FOR PERCOLATION TESTING AND SITE EVALUATION

PROPERTY LOCATION	ant Diant	i i ct	1.0000	22
SUBDIVISION/PROPERTY NAME 13072	Jain Patricks	COMI	LOT N	0. 45
PROPERTY ADDRESS 13072 SAINT	Patricks Cour	t Highla	nd 2017	7
STREET		TOWN/PO	ST OFFICE	
TAX MAP PAGE(S) 34 GRID	PARCEL(S)	855 PR	OPOSED LOT SIZE	1.84 Ac.
AS APPLICANT, I UNDERSTAND THE FOLLOW	VING: THE SYSTEM INST	ALLED SUBSEQUENT T	O THIS APPLICATIO	ON IS ACCEPT-
ABLE ONLY UNTIL PUBLIC SEWERAGE IS AV	AILABLE. THIS APPLICA	TION IS COMPLETE WH	EN ALL APPLICABL	E FEES AND A
SUITABLE SITE PLAN HAVE BEEN RECEIVED	. I ACCEPT THE RESPO	NSIBILITY FOR COMPLI	ANCE WITH ALL M.	O.S.H.A. AND
"MISS UTILITY" REQUIREMENTS. APPROVA	L IS BASED UPON SATIS	FACTORY REVIEW OF A	PERC CERTIFICAT	TION PLAN.
TEST RESULTS WILL BE MAILED TO APPLICA	ANT. John	James		
	/	SIGNATURE OF APP	LICANT	
HOWARD COUNTY HEALTH DEPARTME 7178 COLUMBIA GATEWAY DRIV

RE: Percolation Test Report; 13072 Saint Patrick's Court

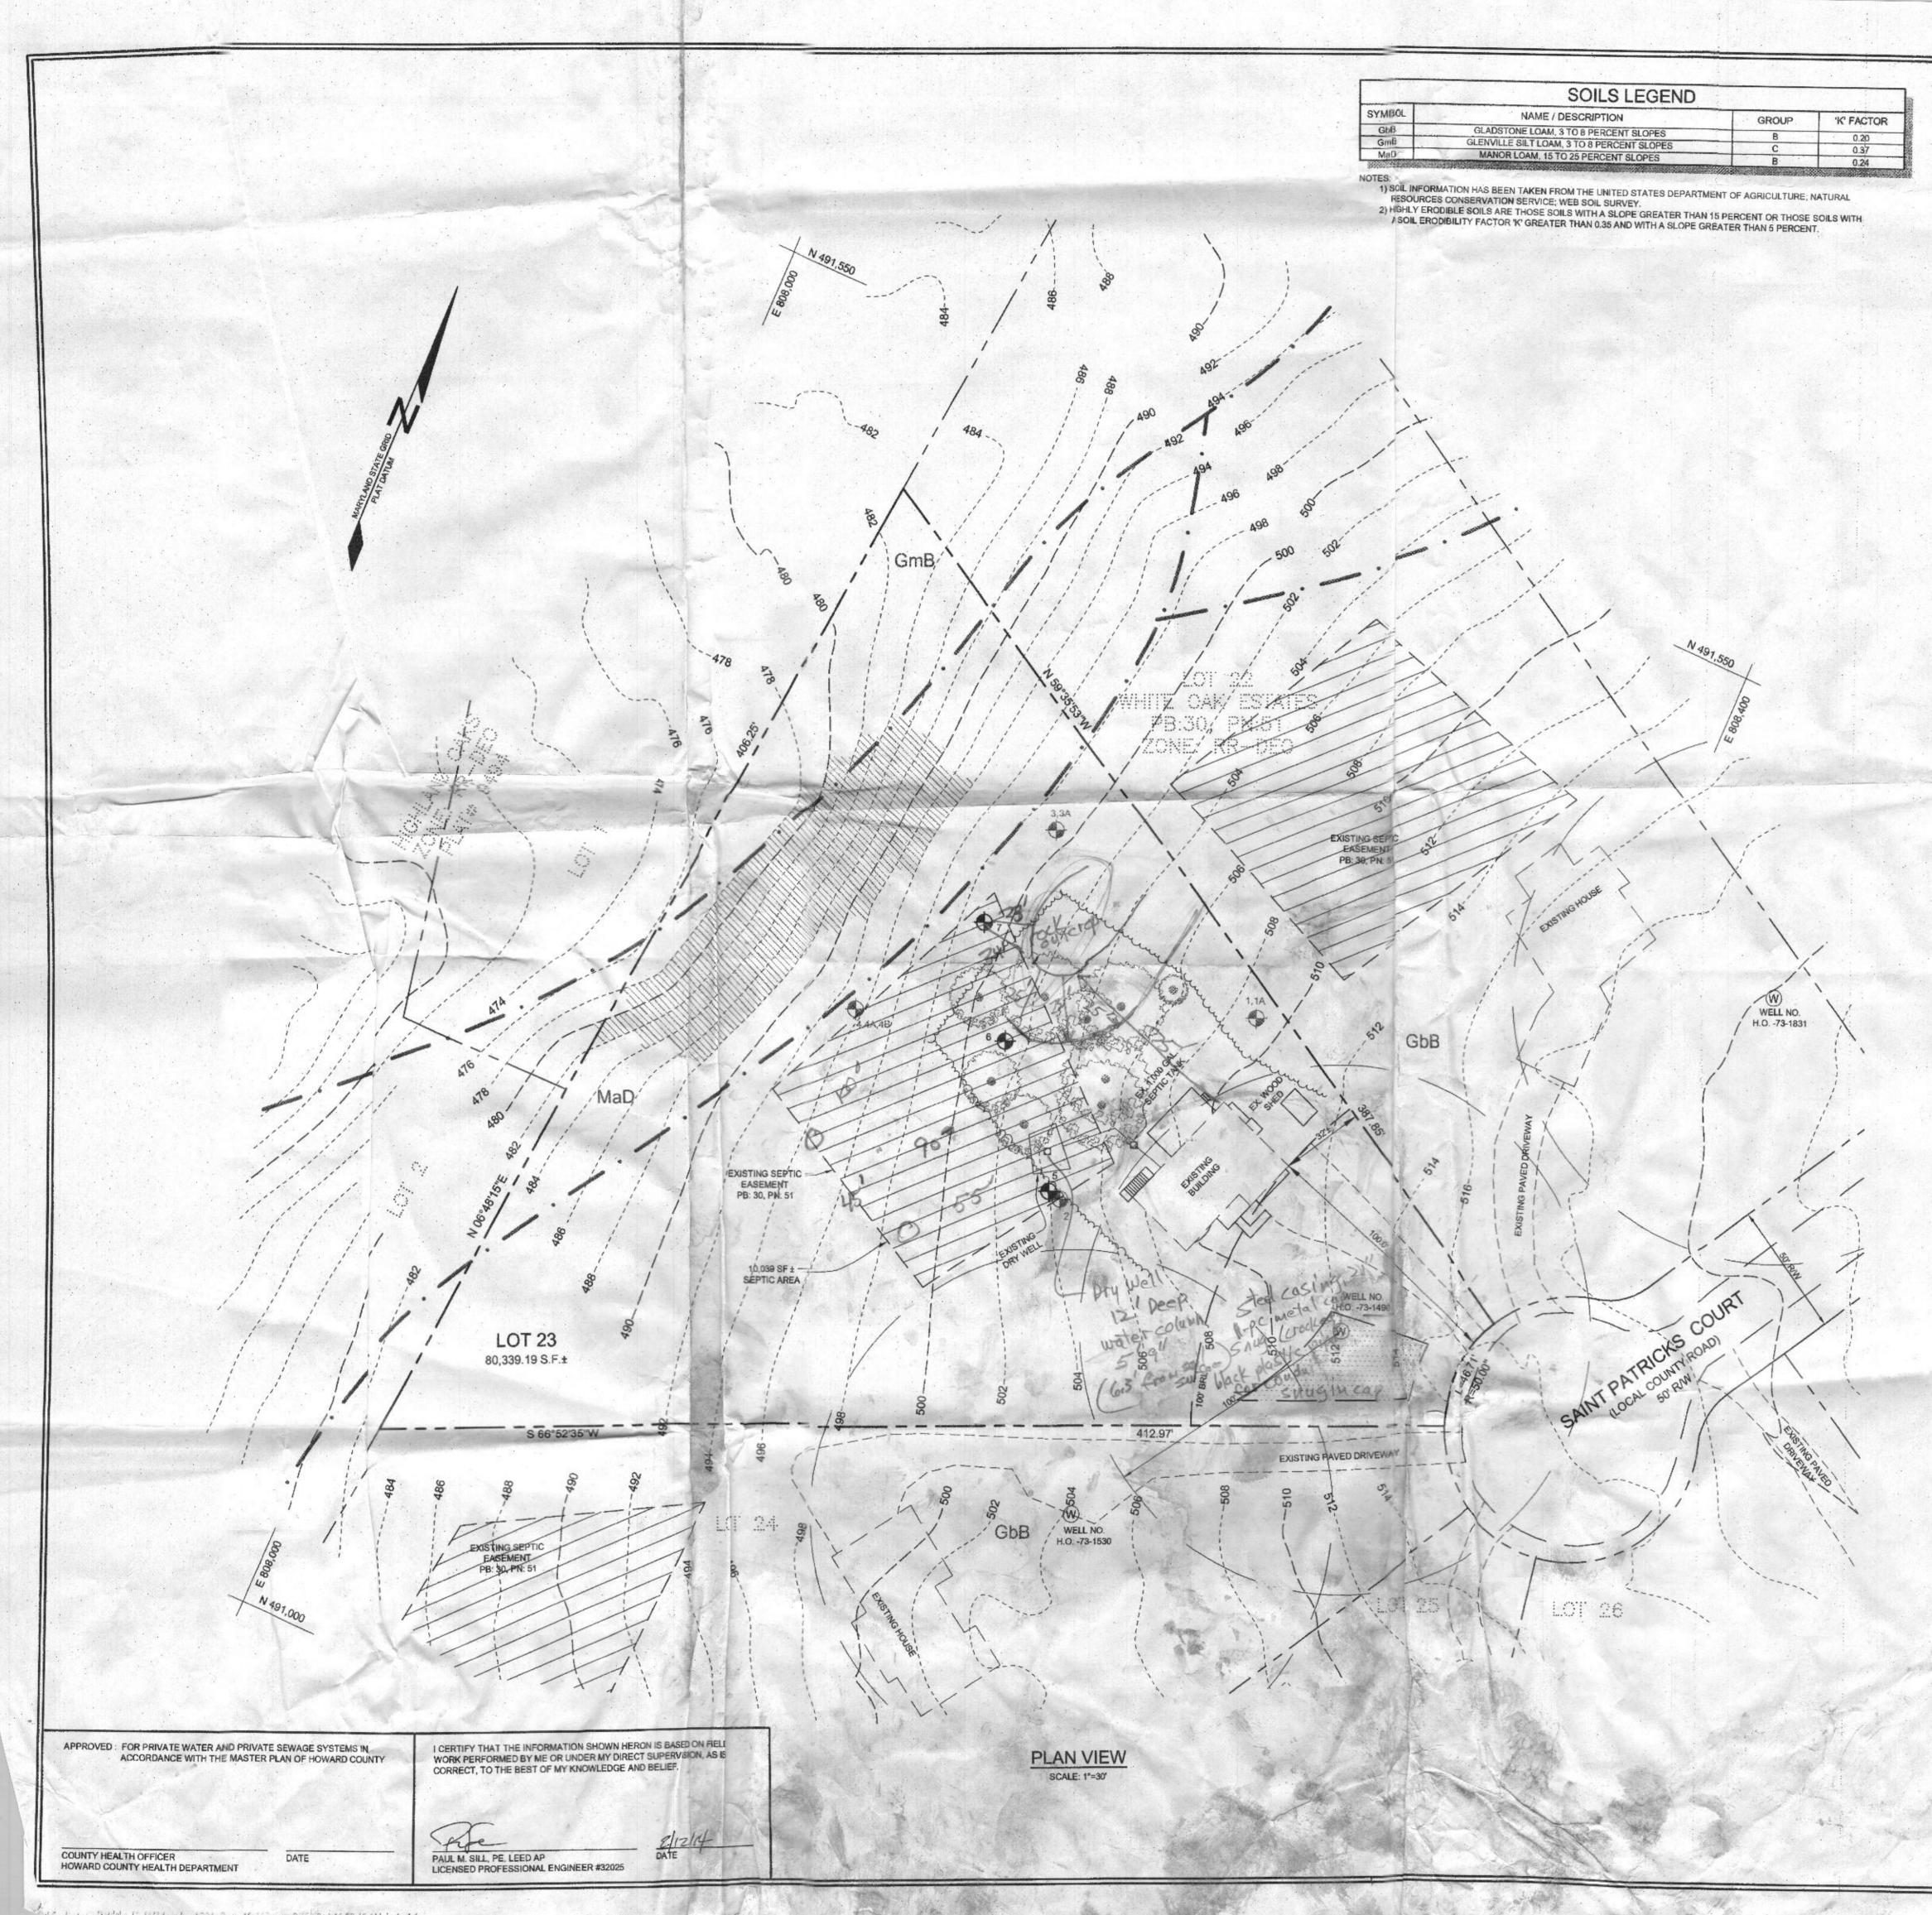
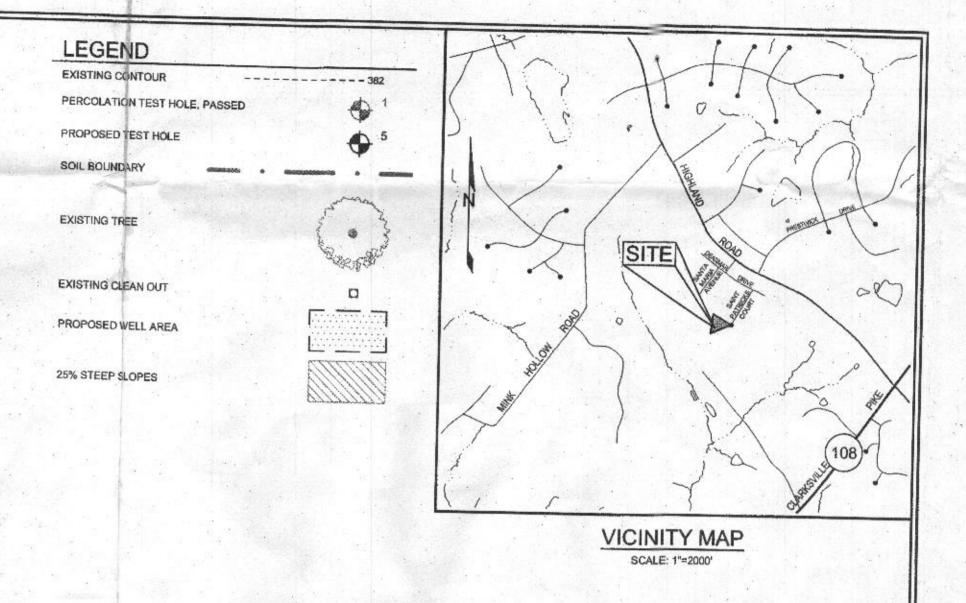
A portion of the property initially included within the area tested on September 19, 1974 is inappropriate for wastewater disposal due to quartzite rock outcrops. The outcrop area is 24 feet from stake '7', and 30 feet from stake '6'. A setback of 25 feet is required from the outcrop boundary to a trench or potential SDA.

The soil profile for test location '5' is also used for describing the soil profile relative to the profile in which the existing dry well which was installed in November 1976. The depth of the dry well is described as 12 feet, and a field measurement on February 21 confirmed that the dry well is 12 feet deep. The column of solution in the dry well on February 21 was about 5.7 feet deep (from the bottom). The description of the soil profile indicates that the layer between 8 feet and 10 feet from the soil surface is greater than 50 % rock fragments. In addition, the back hoe could not dig beyond 12 feet depth. The dry well is FAILED due to absence of a 4-foot buffer between the bottom of the dry well and rock. (See Field Worksheet enclosed with this letter.)

The septic tank installed in 1976 has a capacity of 1000 gallons, permissible for a 3-bedroom residence. The existing structure is reported to have 4 bedrooms. Therefore a septic system upgrade must include a BAT de-nitrification unit.

Summarizing, the existing septic system must be replaced and abandoned. The replacement system will consist of a BAT unit and trenches adequate to receive the estimated discharge from a 4-bedroom residence. The replacement septic system may be installed after the Percolation Certification Plan is signed by the Approving Authority and all permitting requirements are fulfilled.
